Notice of Allowability

09/918,886

YEE ET AL.

EXAMINER'S AMENDMENT

FIG. 16

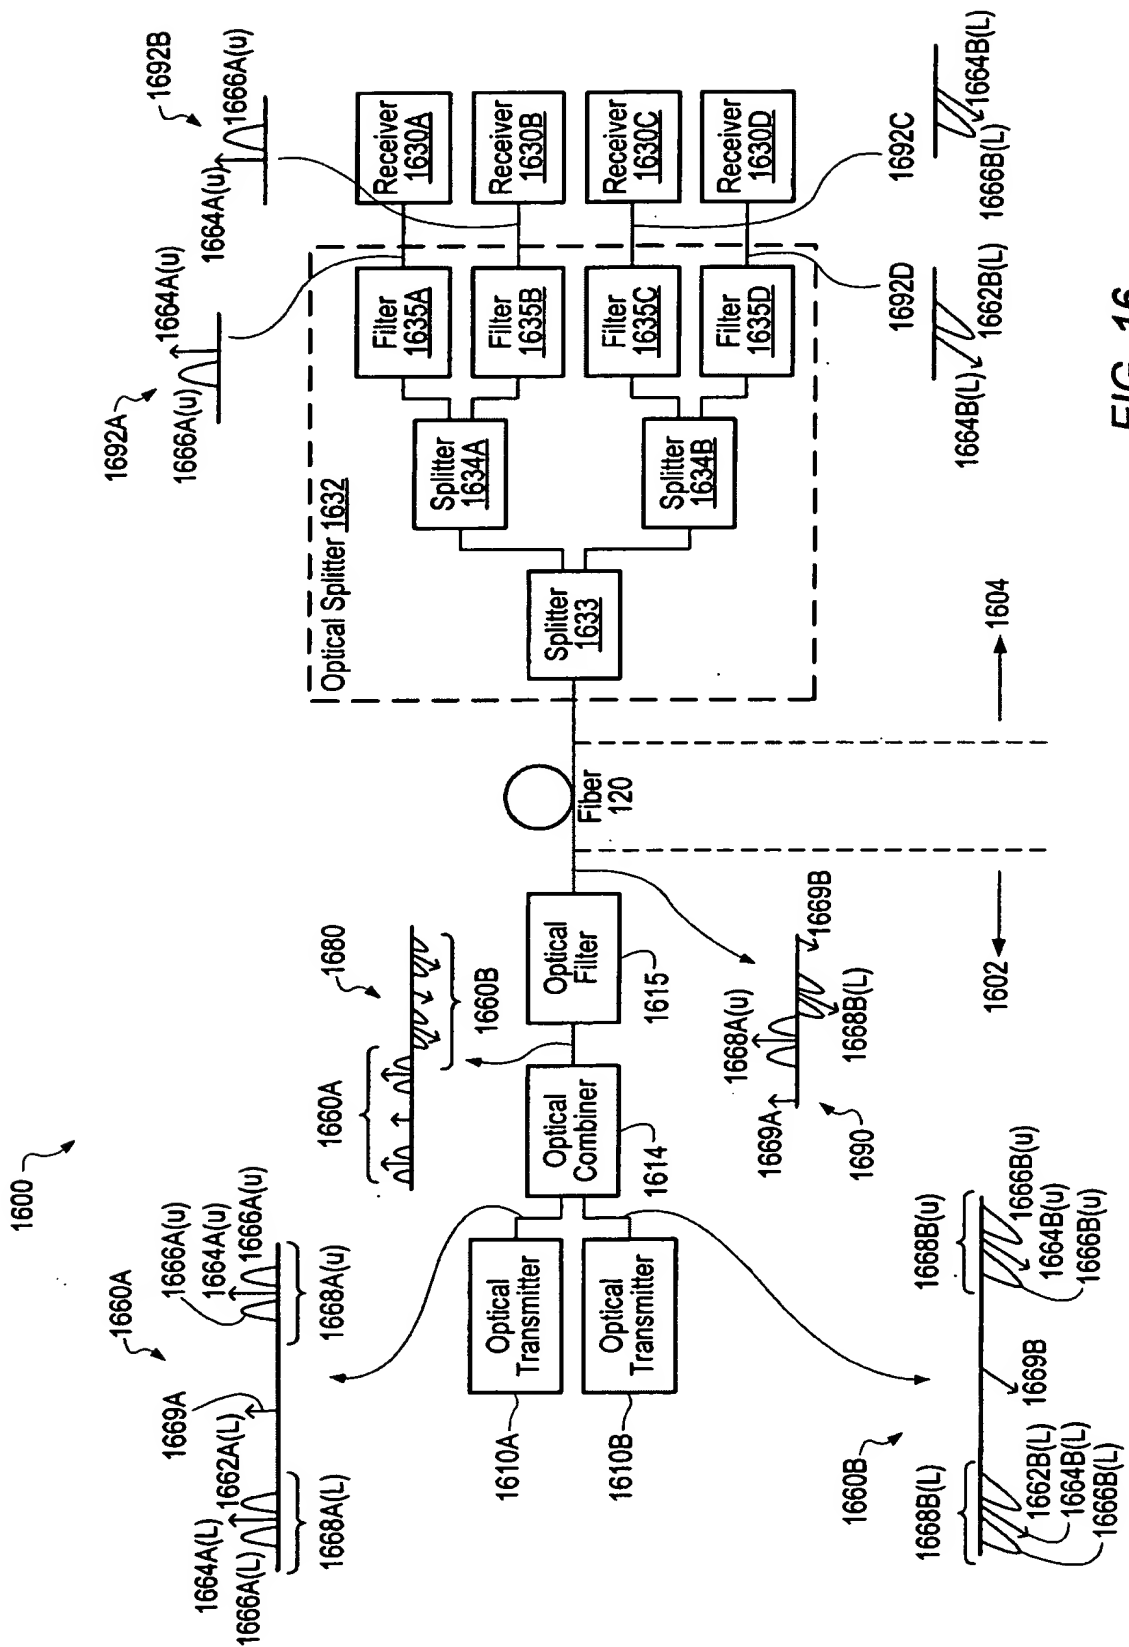
Fig. 16

In the top left corner, there is a spectrum graph. In this graph, there are two instances of “1666A(u)”. Replace the left instance of “1666A(u)” with “1662A(u)”.

In the bottom left corner, there is a spectrum graph. In this graph, there are two instances of “1666B(u)”. Replace the left instance of “1666B(u)” with “1662B(u)”.

Disapproved by DSK
14 July 2006

FIG. 18A

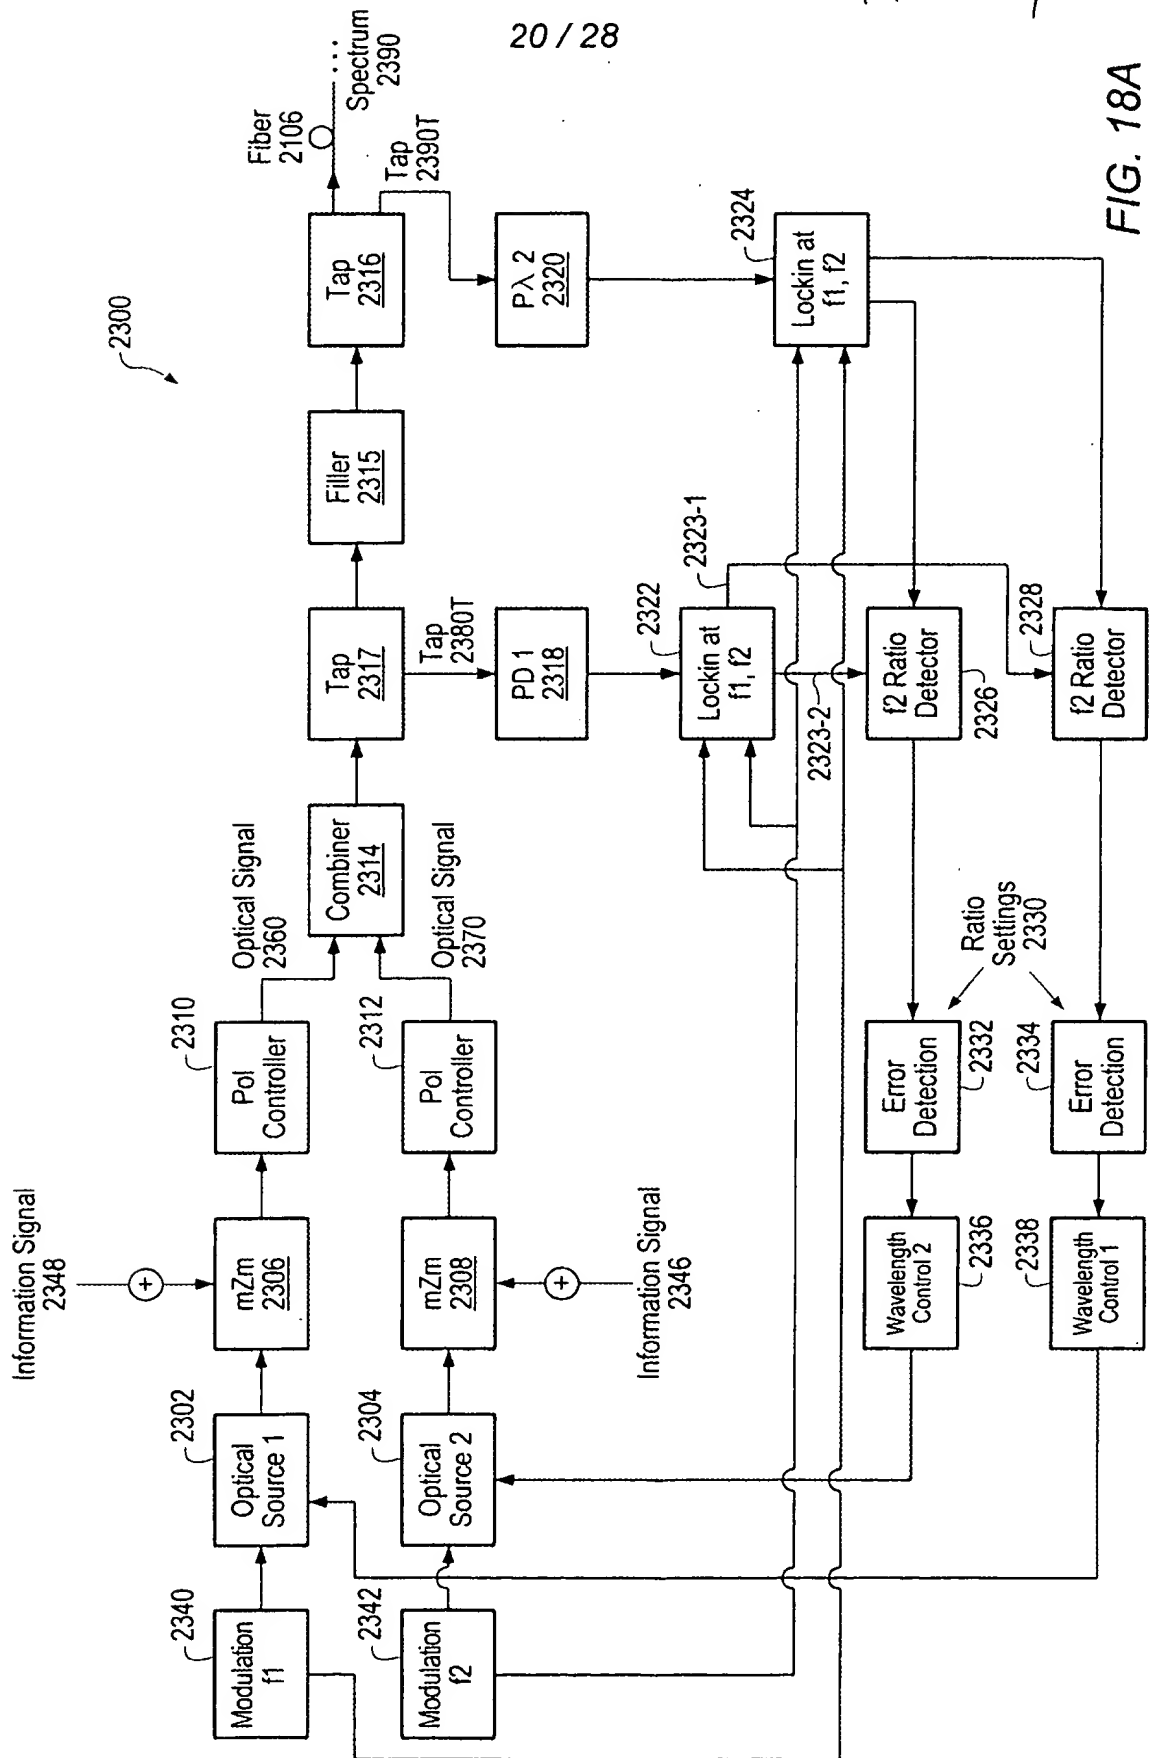
Fig. 18A

The present Fig. 18A was filed on 02 June 2006. This present Fig. 18A is disapproved. Replace this present Fig. 18A with the ***old version of Fig. 18A filed on 17 October 2005*** and make the following changes to this old version of Fig. 18A filed on 17 October 2005:

- ***Under*** optical combiner 1614 and optical filter 1615, remove the following: detector 1818, detector 1820, synchronous detector 1822, synchronous detector 1824, comparison circuitry 1834, and all of their associated input and output lines.

- From the second sinusoidal generator F2, draw lead lines that couple the second sinusoidal generator F2 to synchronous detector 1822 (located ***above*** optical combiner 1614 and optical filter 1615) and synchronous detector 1824 (located ***above*** optical combiner 1614 and optical filter 1615), similar to the lead lines that couple the first sinusoidal generator F1 to these same synchronous detectors.

- From comparison circuitry 1834 (located ***above*** optical combiner 1614 and optical filter 1615), draw a lead line that couples this comparison circuitry 1834 to laser 1712B, similar to the lead line that couples this comparison circuitry 1834 to laser 1712A.

- Replace "1660" in the upper half of the figure with "1660A".
- Add "1660B" under "Signal" in the bottom half of the figure.
- Add a reference character "1800" that points to the entire device. See paragraphs [0044-0045, 0126] for support.

Disapproved by PSK
14 July 2006

In order to avoid abandonment of the application, applicant must make these above agreed upon drawing changes.
